| 8802-3/802.3 REVISION REQUEST 1165 |

REQUESTED REVISION:  
STANDARD: IEEE Std. 802.3af-2003  
CLAUSE NUMBER: 33C.1.4  
CLAUSE TITLE: Capacitive load for inrush current test

Figure 33C.3:  
Change  $C_{pd}$  to  $C_{test}$ .

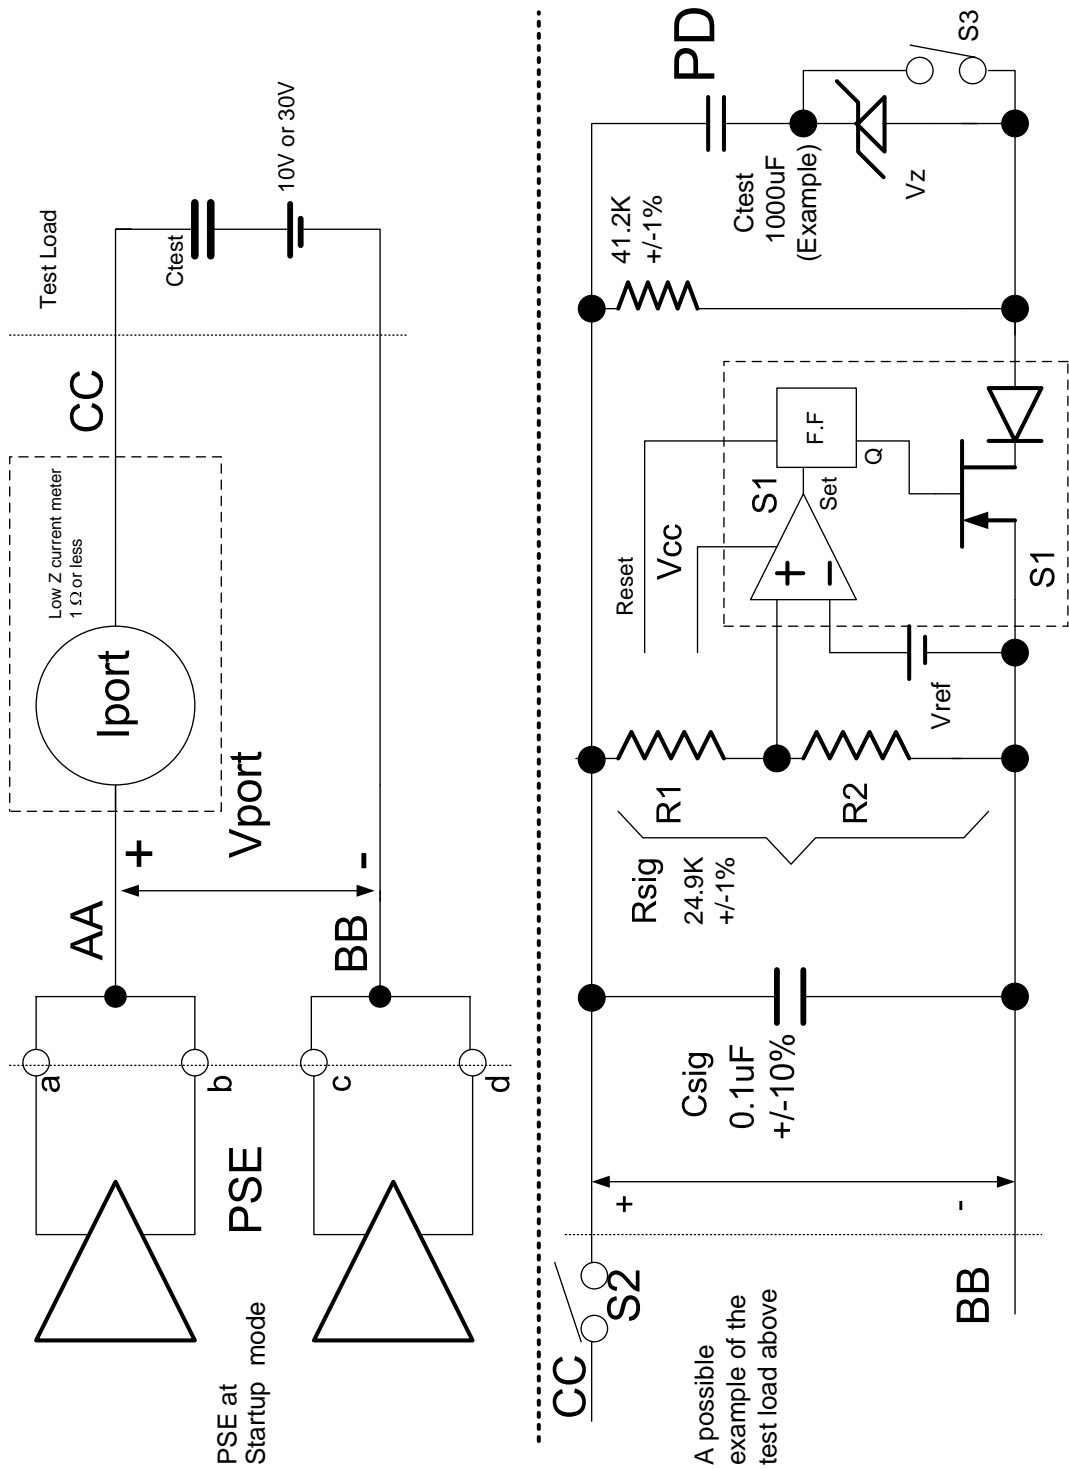
The figure showing  $C_{test}=1000uF$  (which was  $C_{pd}=1000uF$ ) in the example causes confusion with the specified maximum  $C_{pd}$  which is 180uF per 33.3.5.3.

To "3. The capacitive load value  $C_{test}$  is chosen to emulate inrush current during a startup mode condition.  $C_{test}$  is chosen larger than that allowable for  $C_{pd}$  to ensure the PSE stays in Inrush current limit for  $>75mS$  or until  $T_{lim}$  is reached. Smaller  $C_{test}$  capacitor values can be used as long as  $C_{test} > I_{inrush} * T_{lim} / V_{port}$ .
